# Valley of the Winds Wind Farm

## Addendum to Landscape and Visual Impact Assessment

The purpose of this Addendum Report is to provide additional information relevant to the Landscape and Visual Impact Assessment (LVIA) prepared by Moir Landscape Architecture for the Valley of the Winds Wind Farm Project (SSD-10461) referred to hereafter as ‘the Project’.

Since lodging the EIS, ACEN (the Proponent) has made amendments to the 2022 project layout (referred to as the Superseded Layout) in response to matters raised in the submissions and further agency, community and stakeholder consultation. This Addendum Report provides an updated assessment of the revised project layout (referred to as the ‘Revised Layout’).

Figure 5. Revised Layout Multiple Wind Turbine Tool Figure (2023)

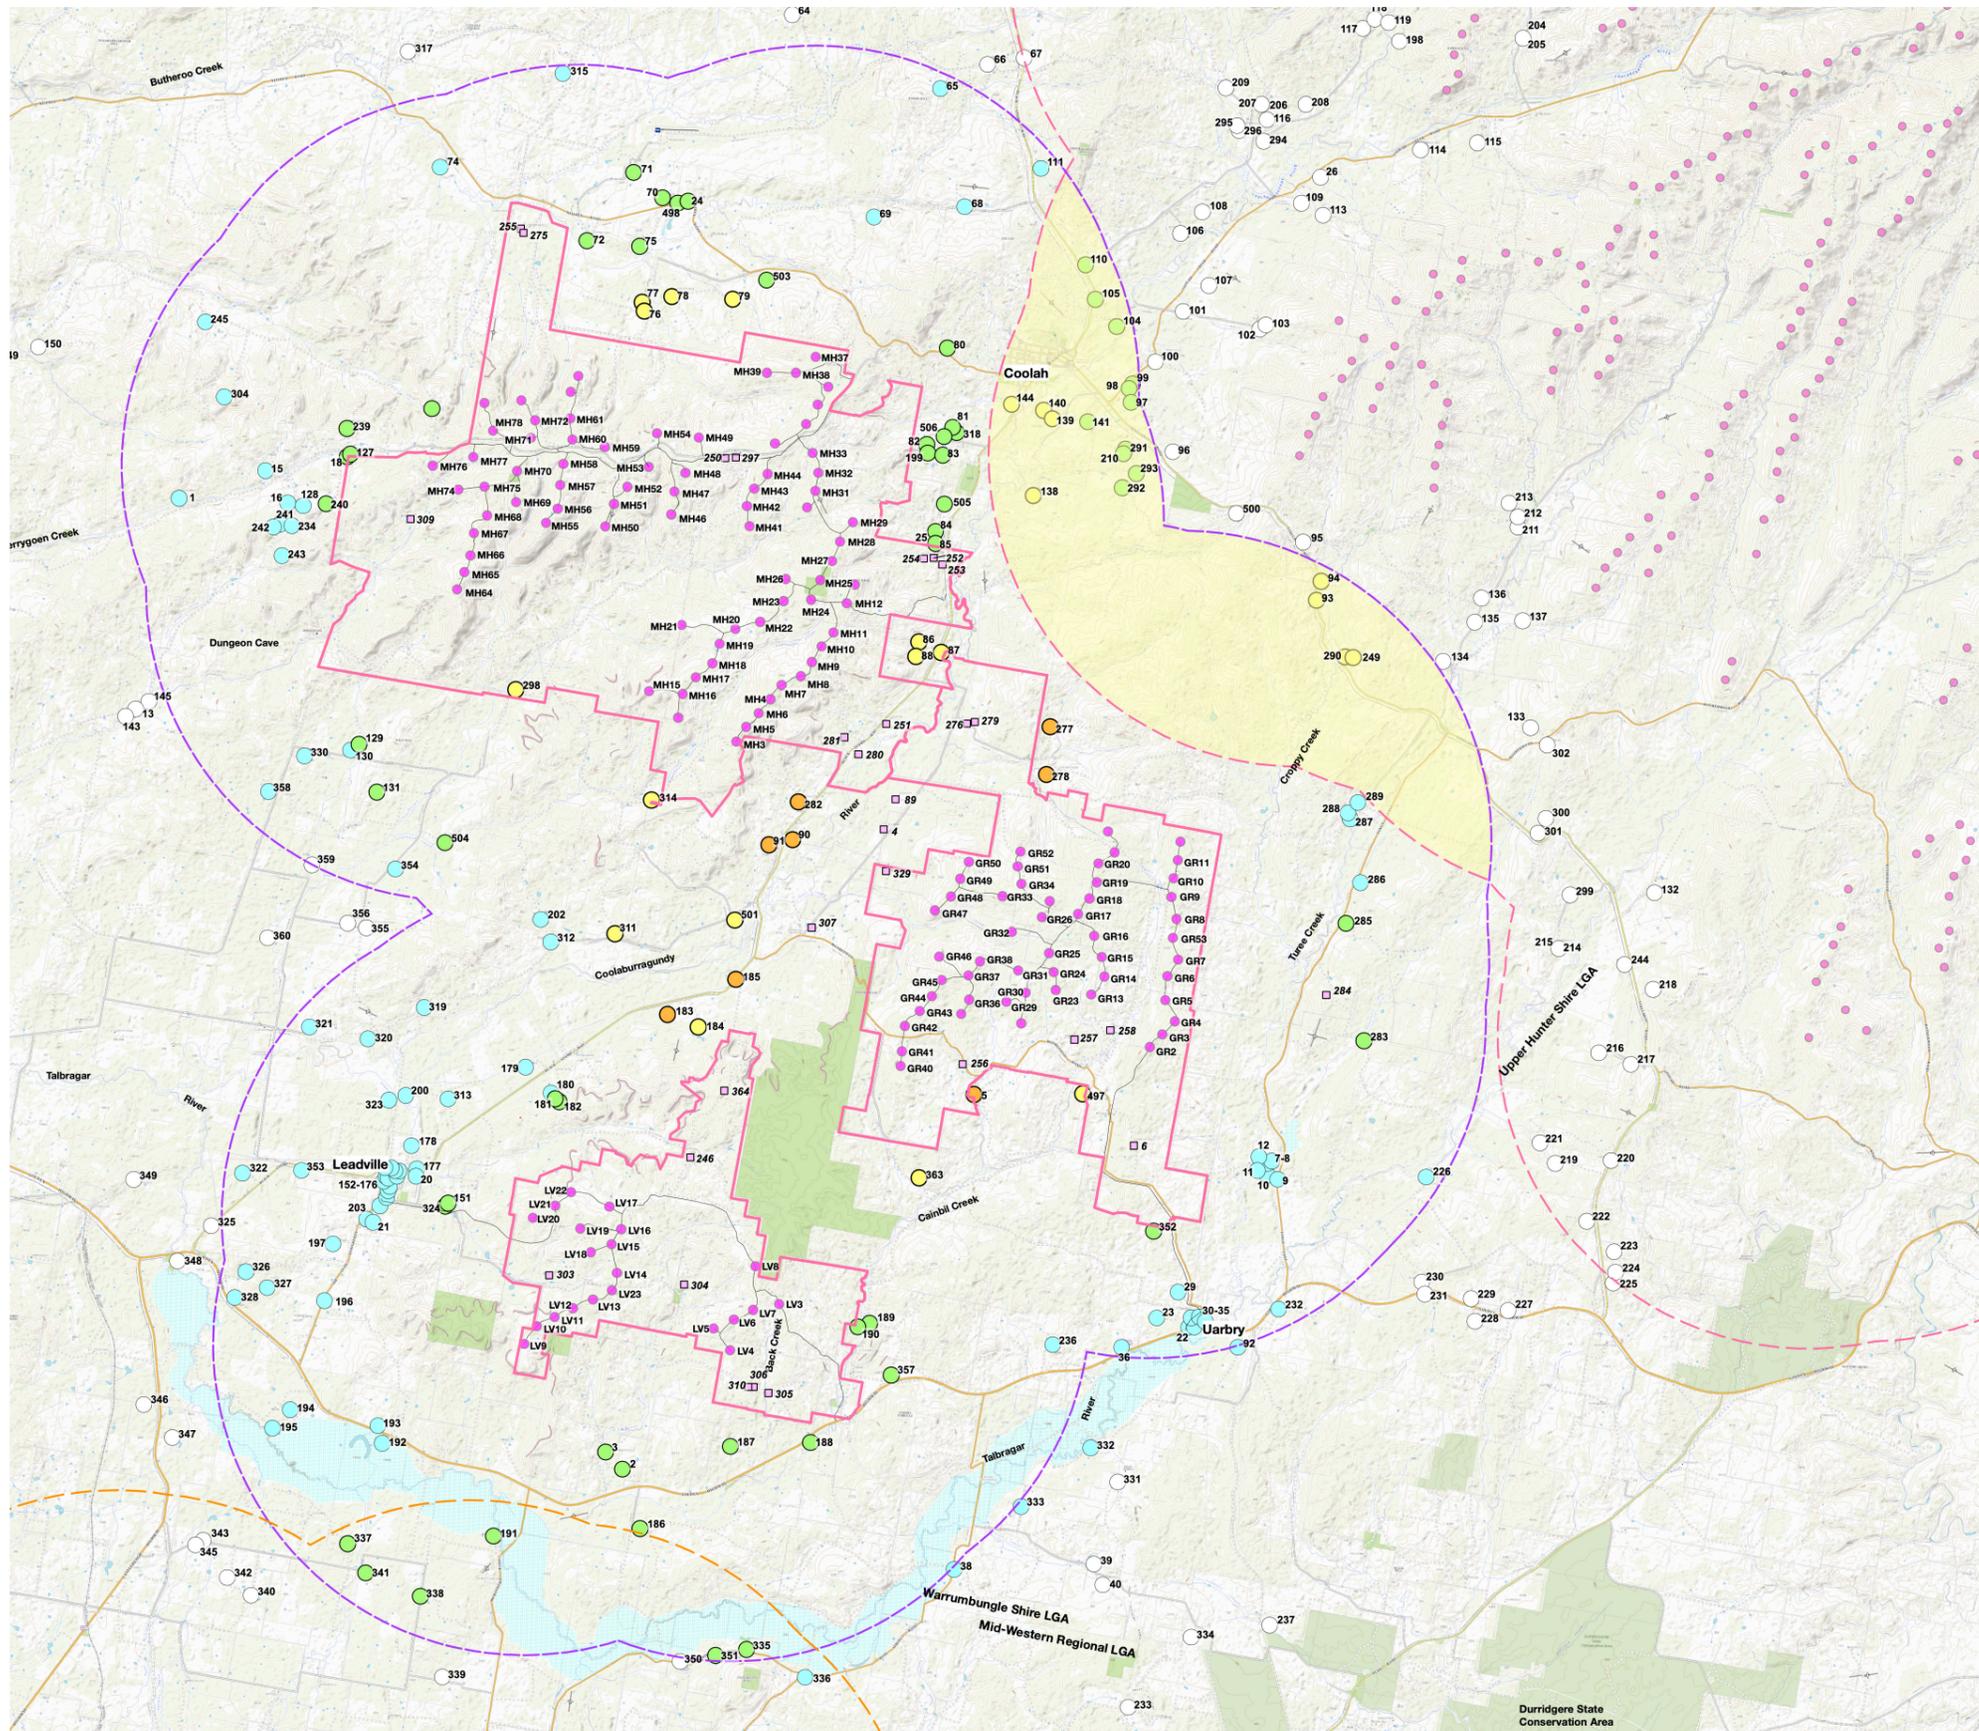
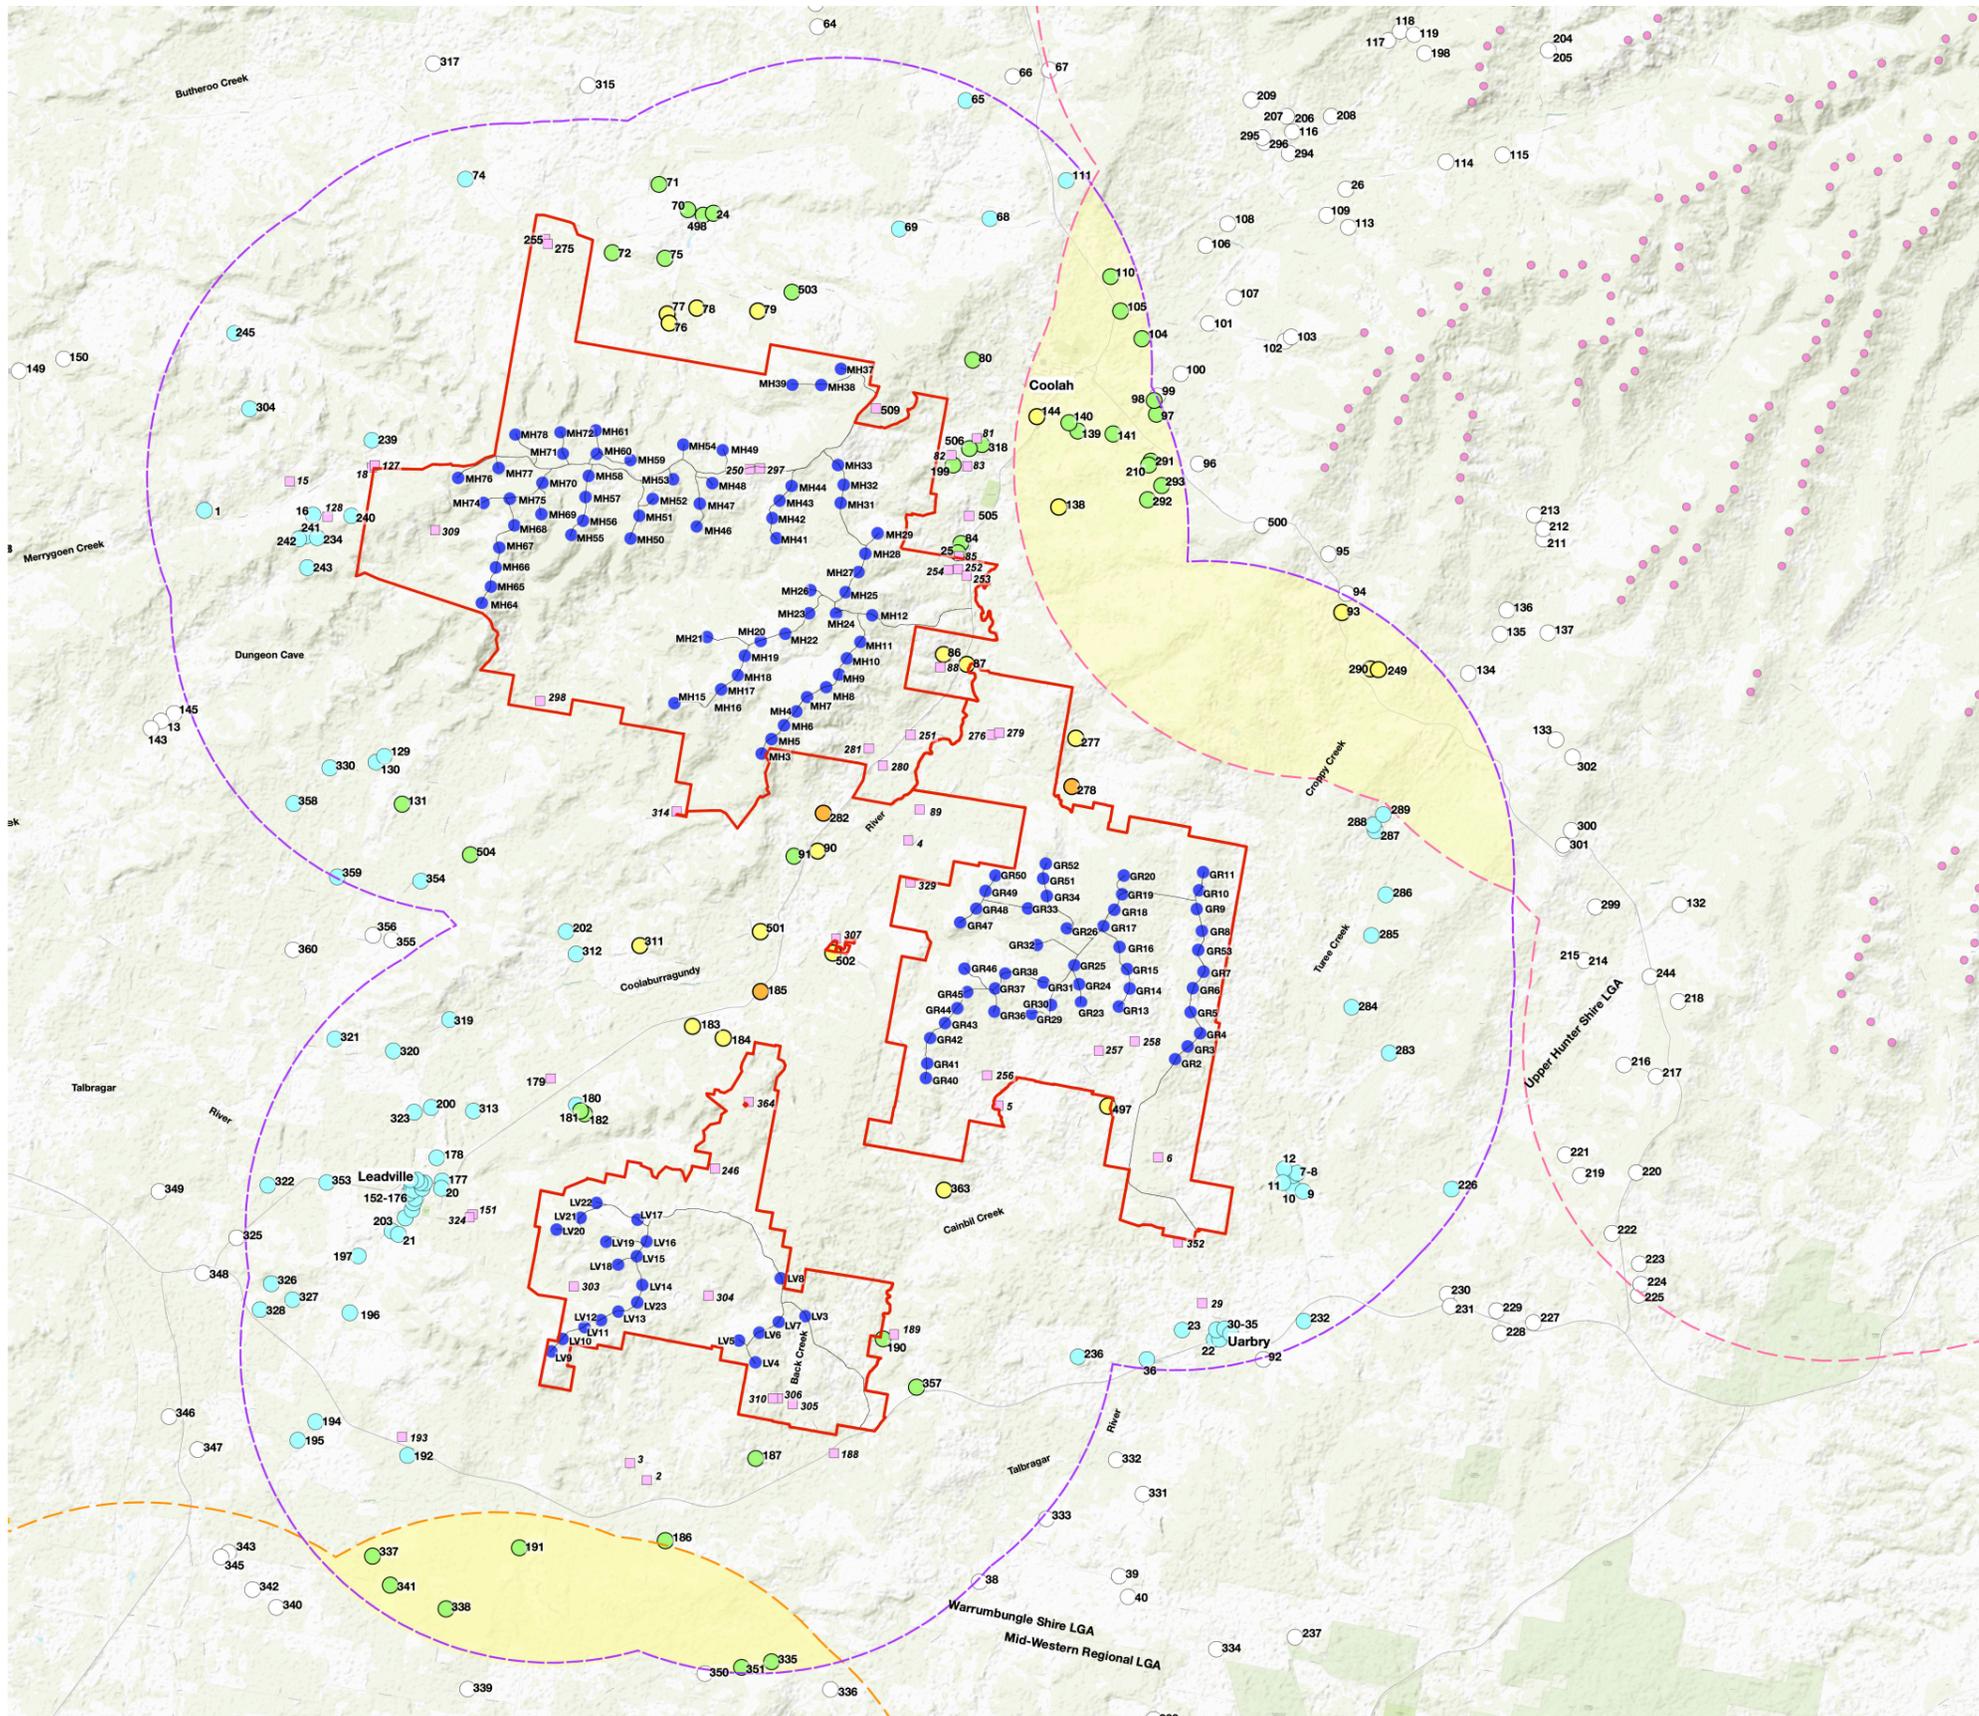
Note: The EIS submission did not take into account turbines associated with Barneys Reef Wind Farm (BRWF). Six (6) non-participating dwellings have up to two (2) 60 degree sectors of turbines associated with the VoW Project and the turbines associated with BRWF which is deemed acceptable (refer to Figure 4).

When applied to the Revised Layout (2023), the 2D Multiple Wind Turbine Tool identified a total of 24 non-participating dwellings with turbines located in more than two (2) 60 degree sectors.

Figure 9. Amendments to Mount Hope Cluster

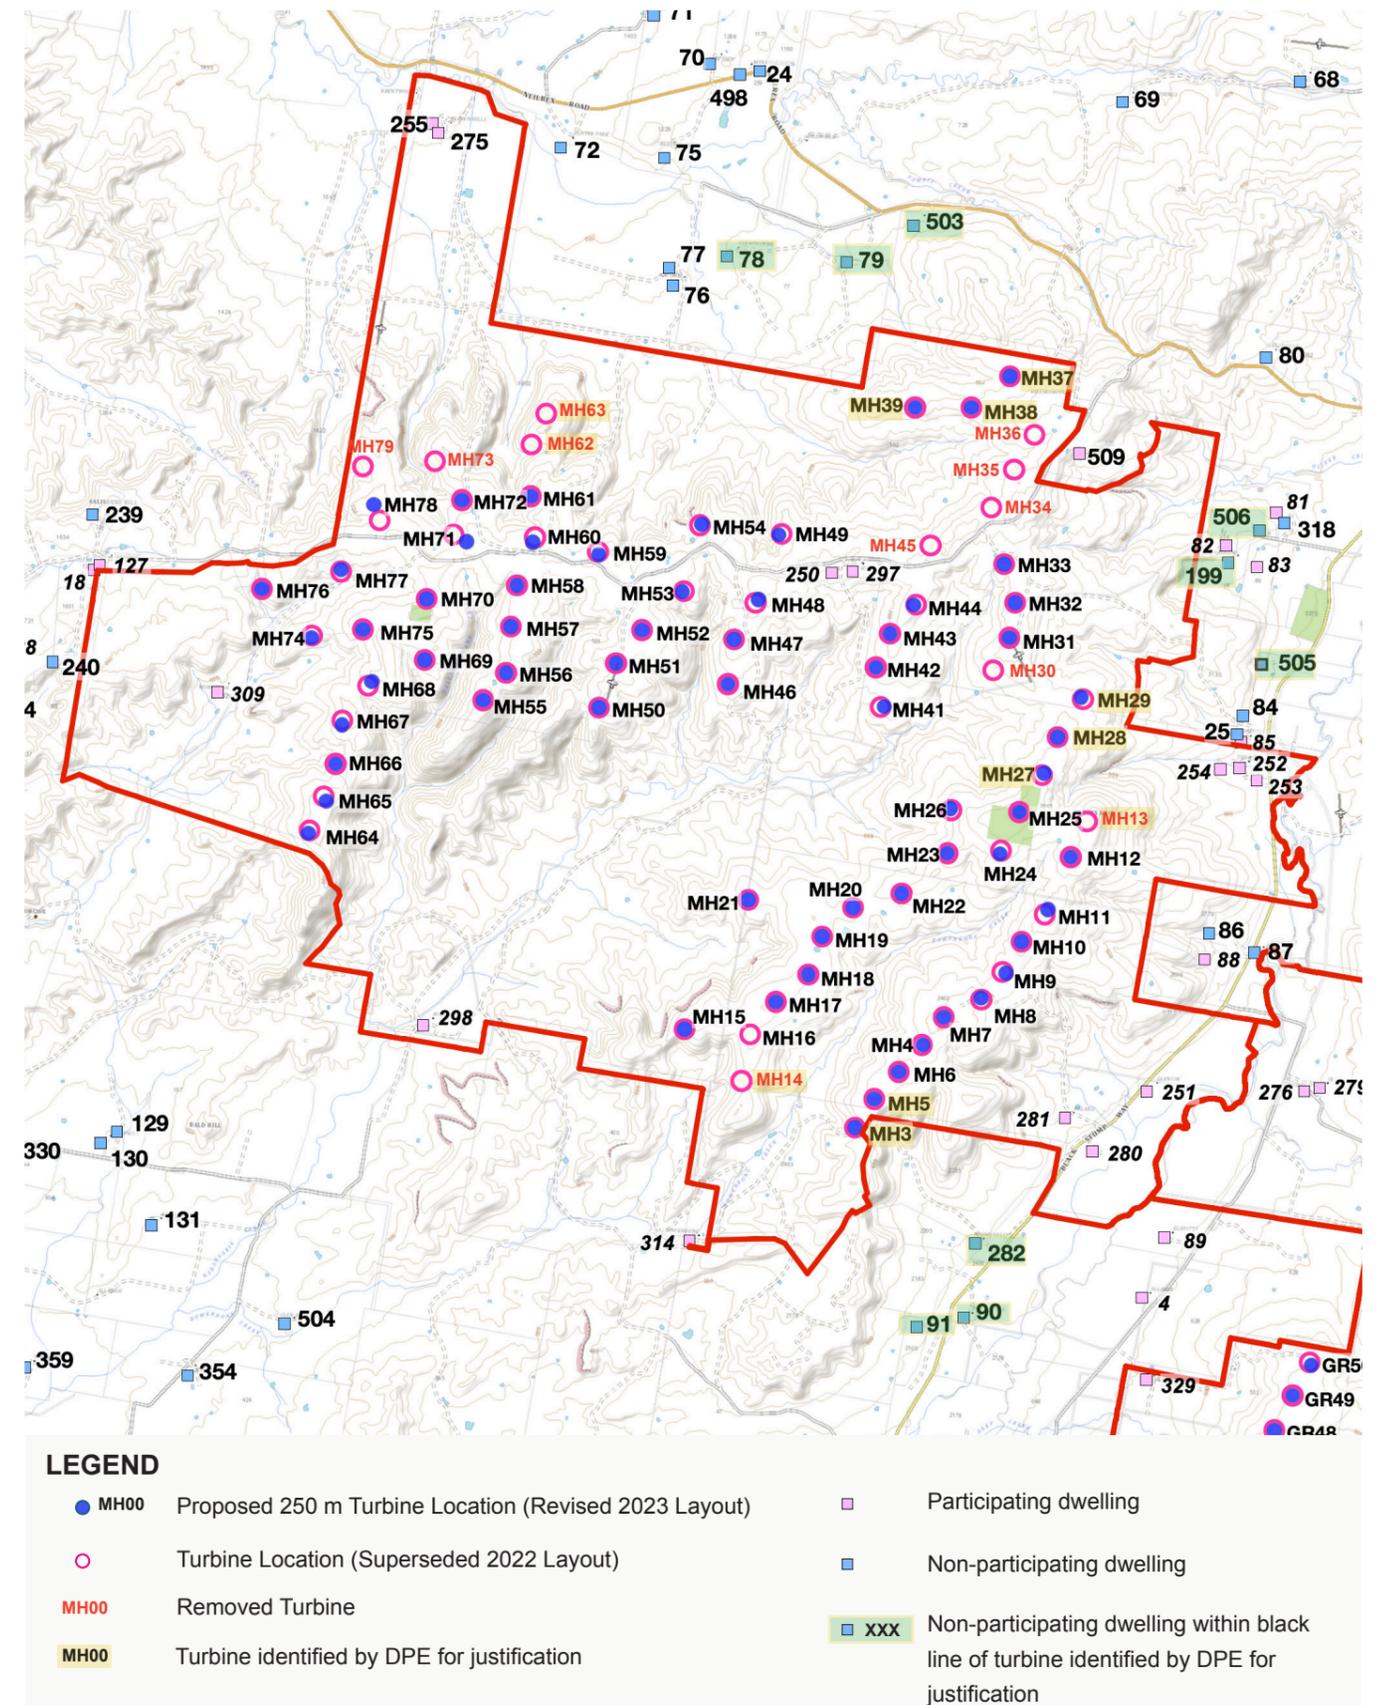
The Mount Hope Cluster of turbines had a total of 76 turbines in the Superseded Layout (2022). In response to visual and biodiversity impacts and the RFI from the DPE, a total of eleven (11) turbines have been removed and eight (8) turbines have been repositioned (refer to **Table 12**). The Mount Hope Cluster has a total of 65 turbines under the revised layout. **Figure 9** illustrates the removal and repositioning of turbines.

The DPE identified 13 turbines in the Mount Hope Cluster to consider and justify impacts. Four (4) of these turbines have been removed to reduce visual impacts to nearby dwellings. Nine (9) turbines have been retained in the Revised Layout.
